Adequacy of SWRCB's Draft SED Update of Bay-Delta WQCP; Phase I San Joaquin River Flows Southern Delta Water Quality

March 20, 2013

U.S. Department of the Interior
Bureau of Reclamation

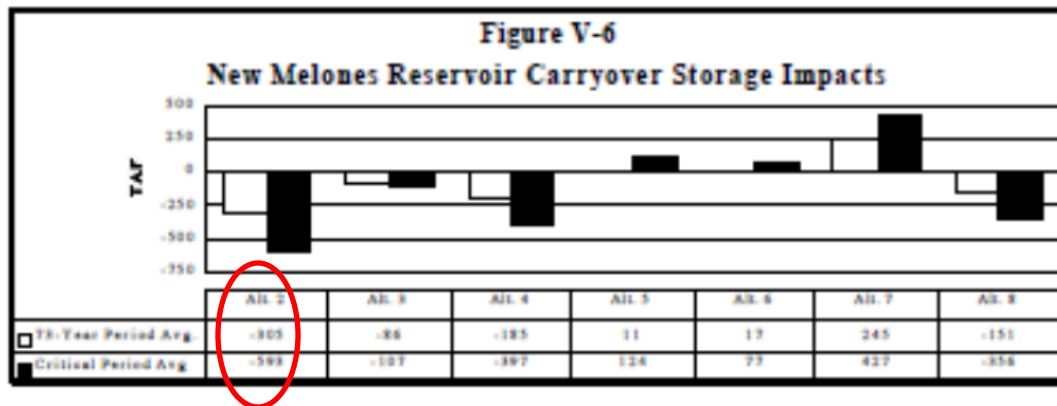
- Modeling Issues with No Project Alternative:
 - SWRCB's 1995 WQCP EIR demonstrates NM cannot solely meet D-1641, Table 3:

- 2009 NMFS BiOp: “relying on New Melones Reservoir to provide the flows at Vernalis cannot be sustained” → adverse Impacts on CV Steel-head due to Temperature

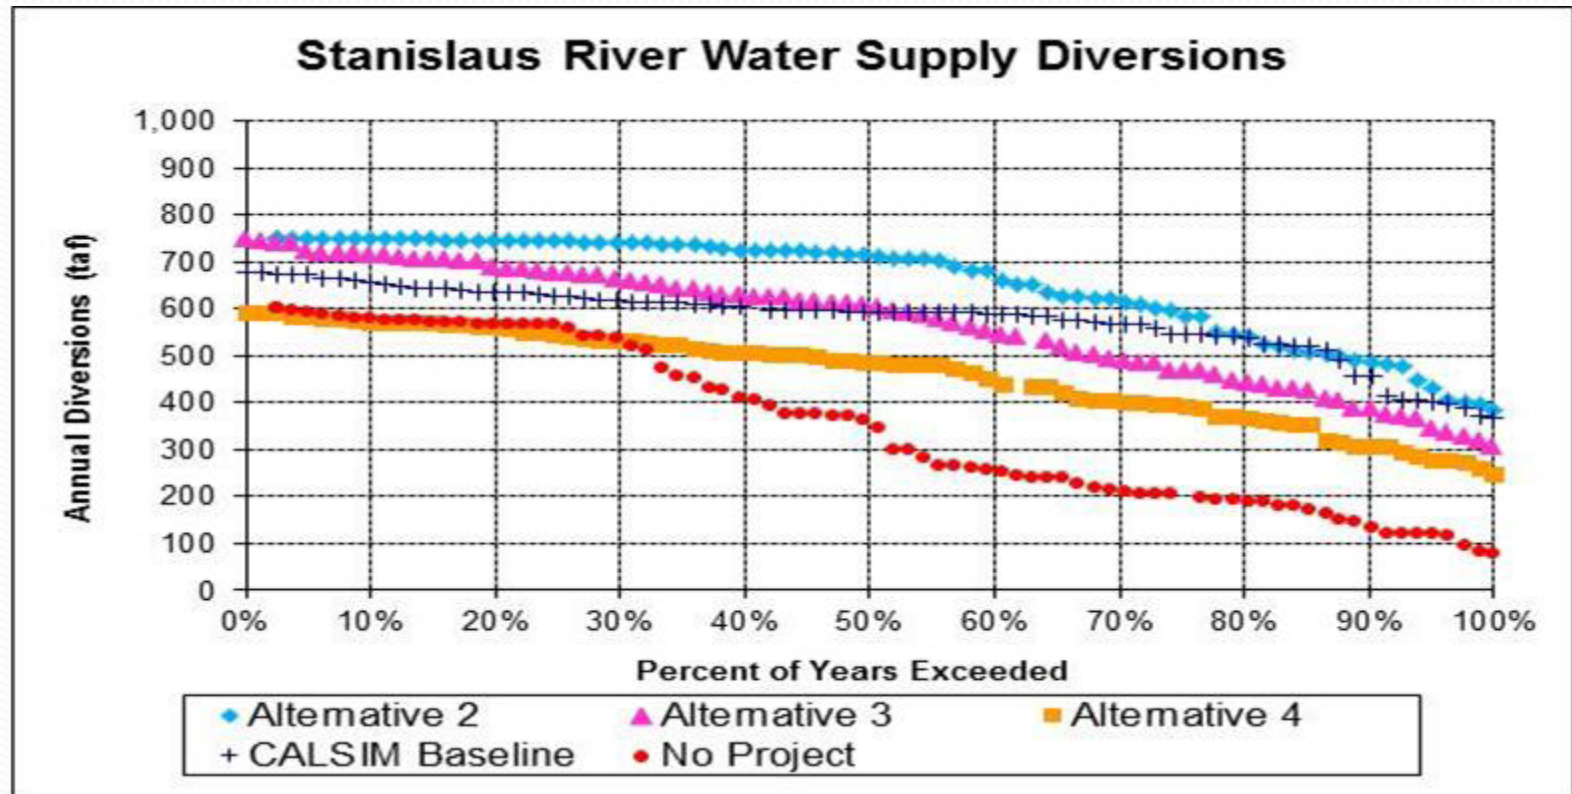
- Modeling Issues with No Project Alternative:
 - SWRCB Modeling is Inconsistent with 1988 Stipulation Agreement
 - Shortages to Senior Water Right Holders' (OID/SSJID) 600 TAF are NOT based on New Melones Index, but rather on inflow as specified in the 1988 Stipulation Agreement
 - Reclamation does NOT make Releases to meet Southern Delta Salinity Objectives directly; rather releases are made to meet Salinity Control Objectives at Vernalis
 - No Dissolved Oxygen Check
 - Prolonged drought operation is inconsistent with 2009 NMFS BiOp

Reclamation Modeling: Storage Impacts

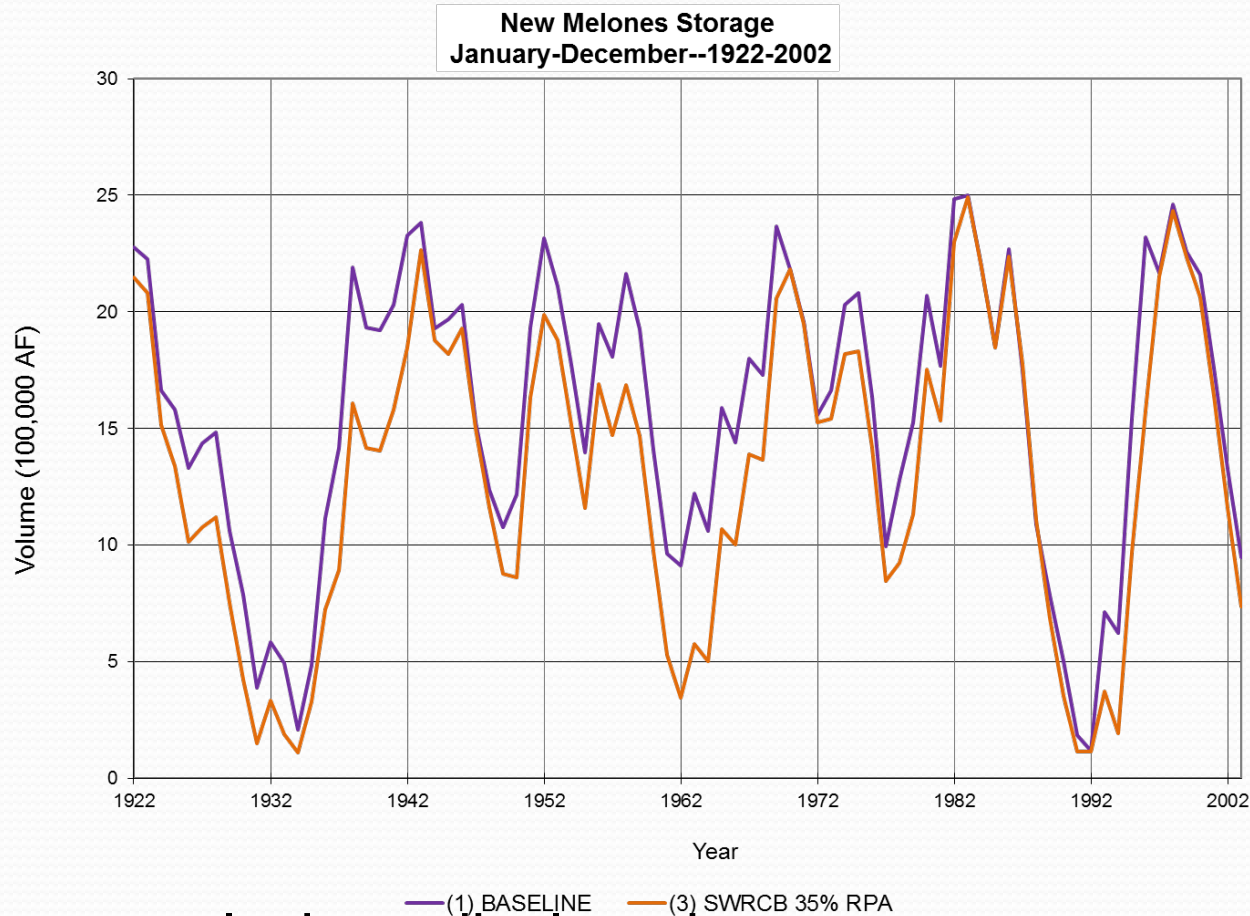
Inadequate analysis to disclose impacts to power, cold water pool and recreation

Power Impacts

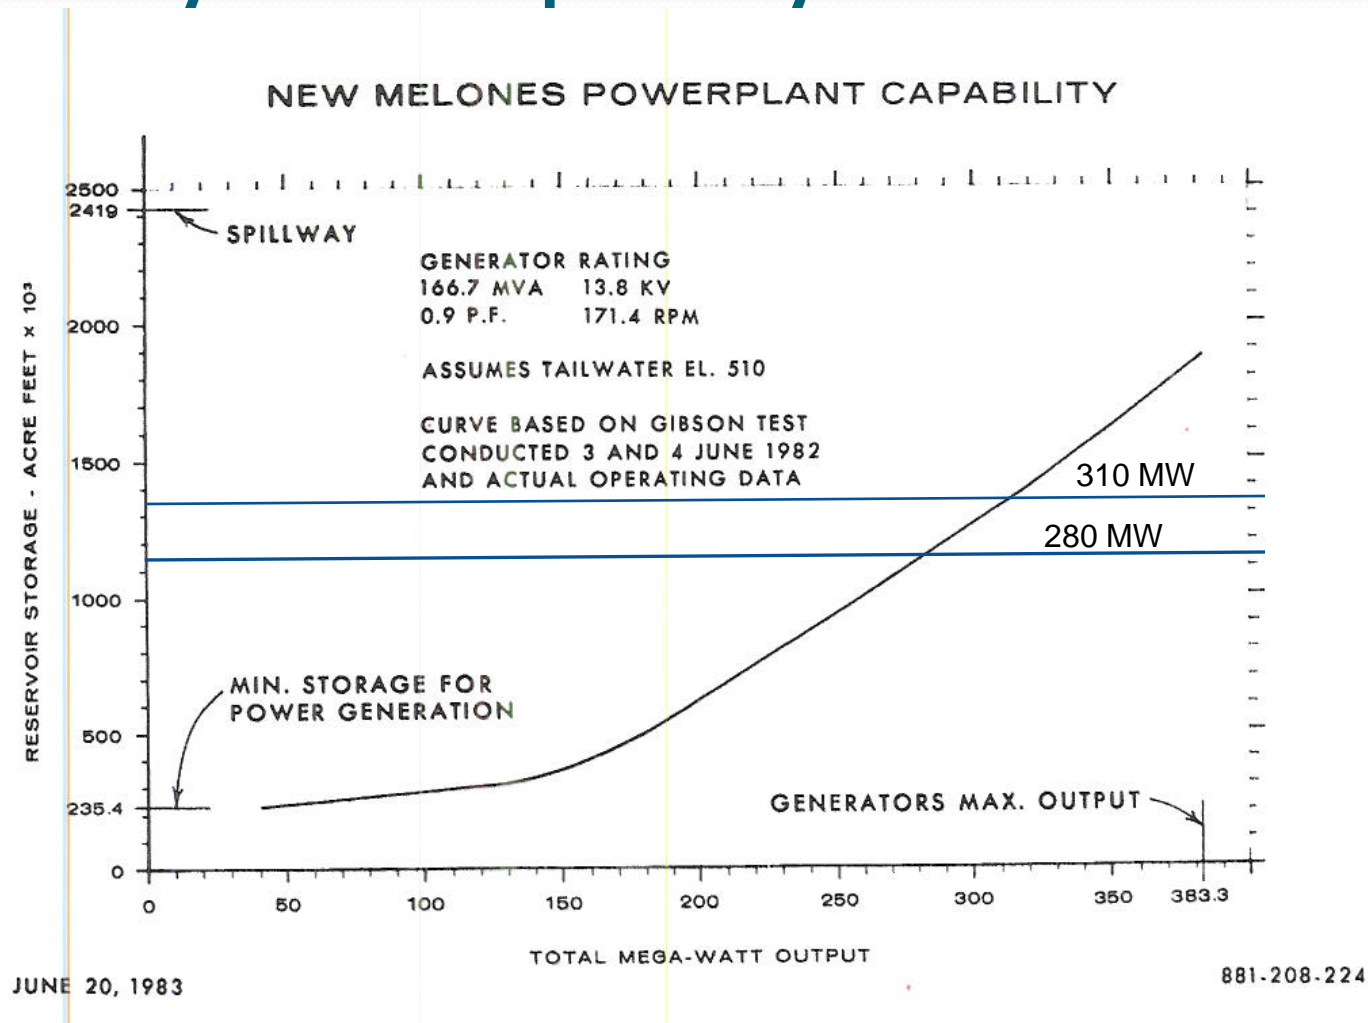
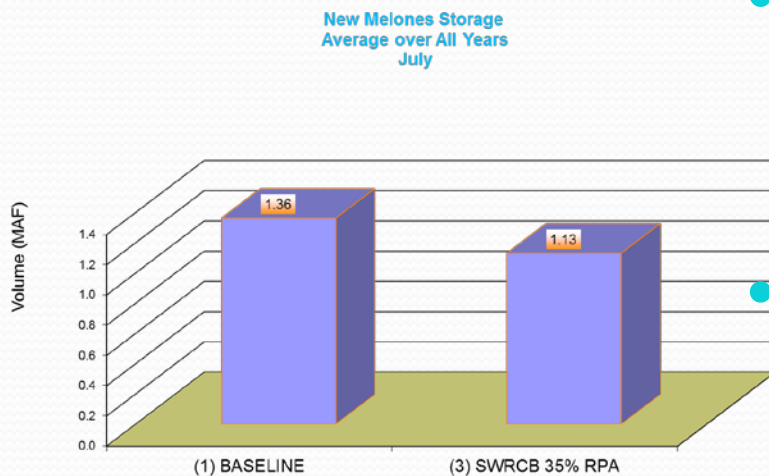
Lower Summer Storage → Less MW Hydro Capacity

Summer Storage Reduced

Peak Capacity Reduced

- At New Melones, average storage reduced from 1.36 MAF to 1.13 MAF → Reduction of Peak Capacity from 310 MW to 280 MW
- Impacts to Resource Adequacy
 - Summer peak hydro capacity reduced
 - 10% at NM on average
 - Droughts exacerbate problem
 - Increased Groundwater Pumping increases peak load

Cold Water Pool Impacts

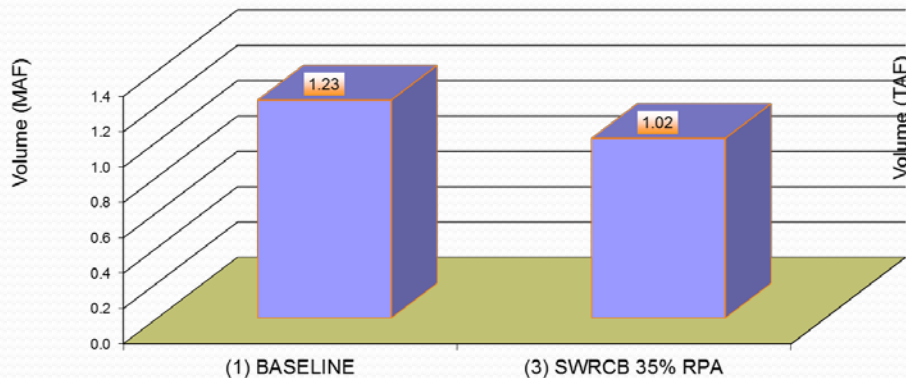
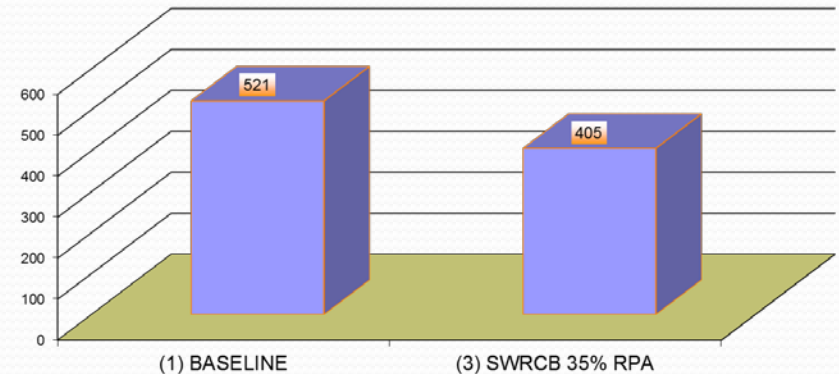
Potentially Significant Impacts to Cold Water Pool especially in Dry Years

Recreation Impacts

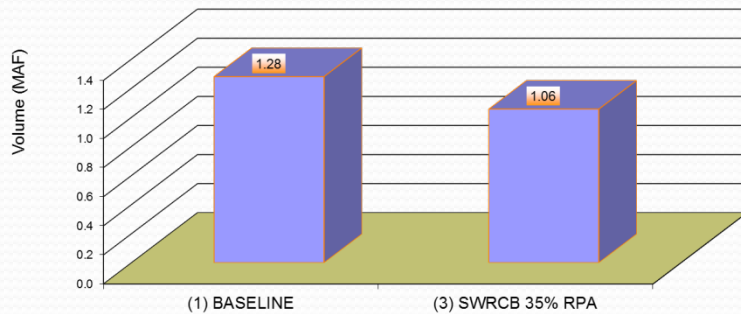
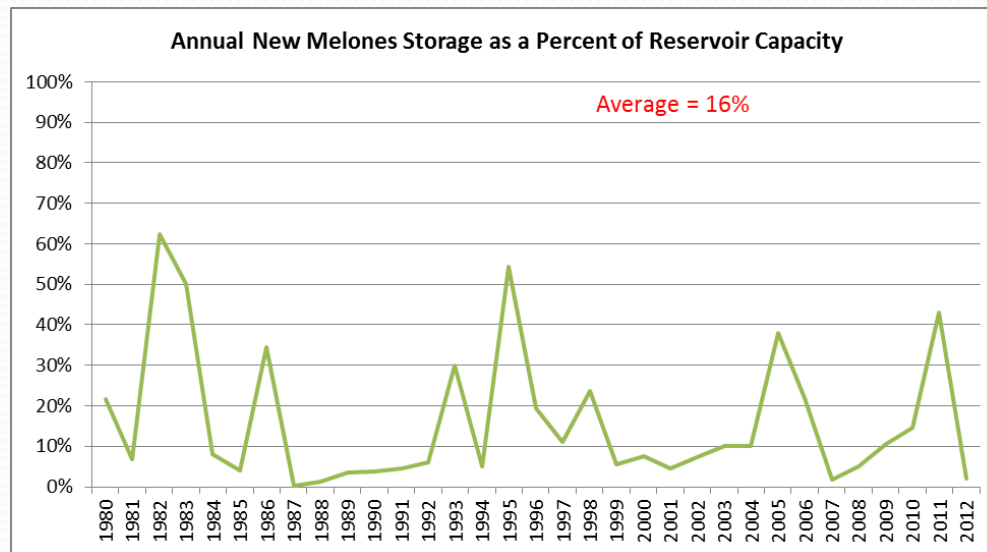
Reduced Summer Storage

Impacts: Boating, Aesthetics

- Below Elev 975, 1.25 MAF, Angels Creek Boat Ramp Unusable
- Below Elev 900, 0.72 MAF, most Boat Ramps Unusable

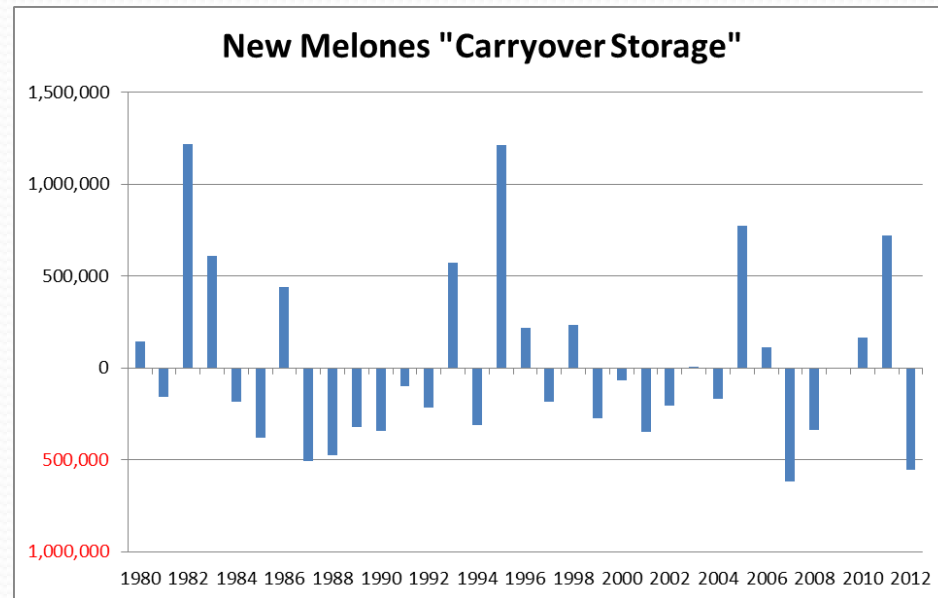
- Carryover Storage will be impacted
- Historical Analysis of Carryover Storage → only occurs 39% of Time:

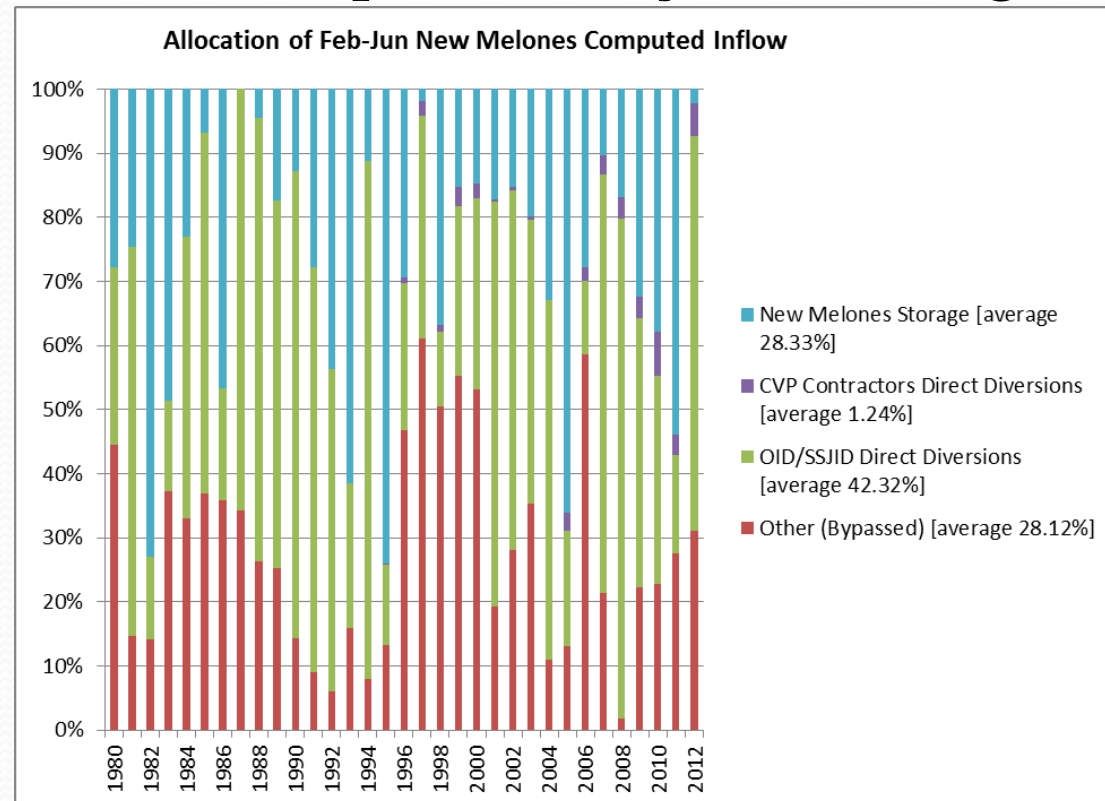
- 35% Bypass Standard impacts Carryover Storage:

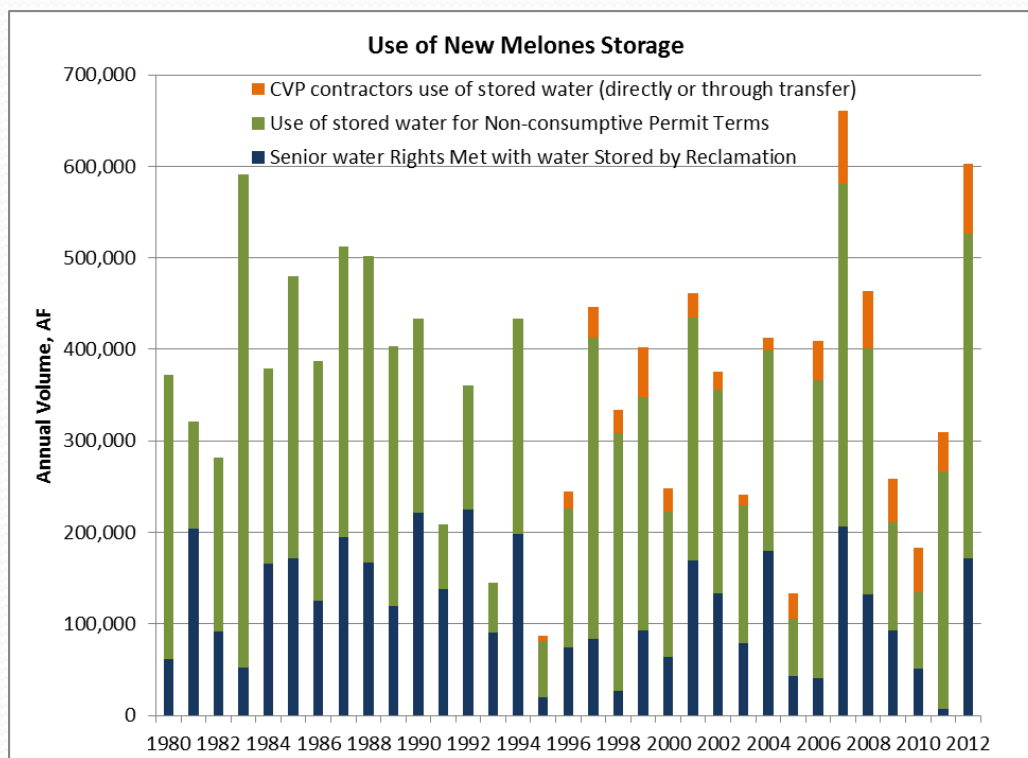
- Historical Analysis → New Melones already Oversubscribed:

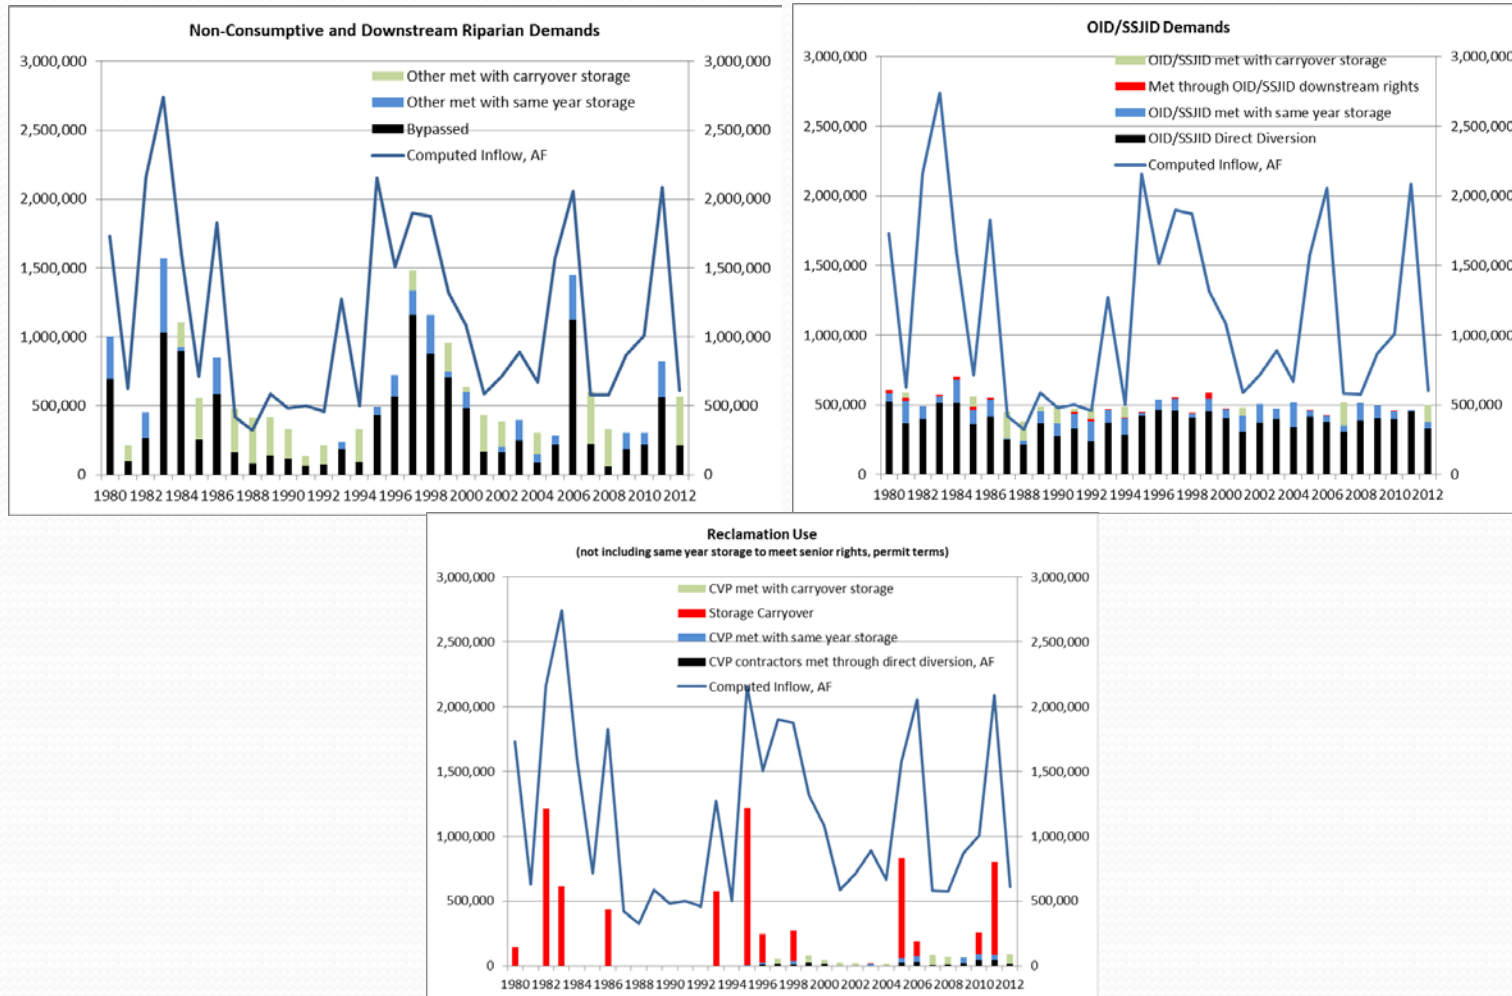
- Historical NM Demands Stress Storage:
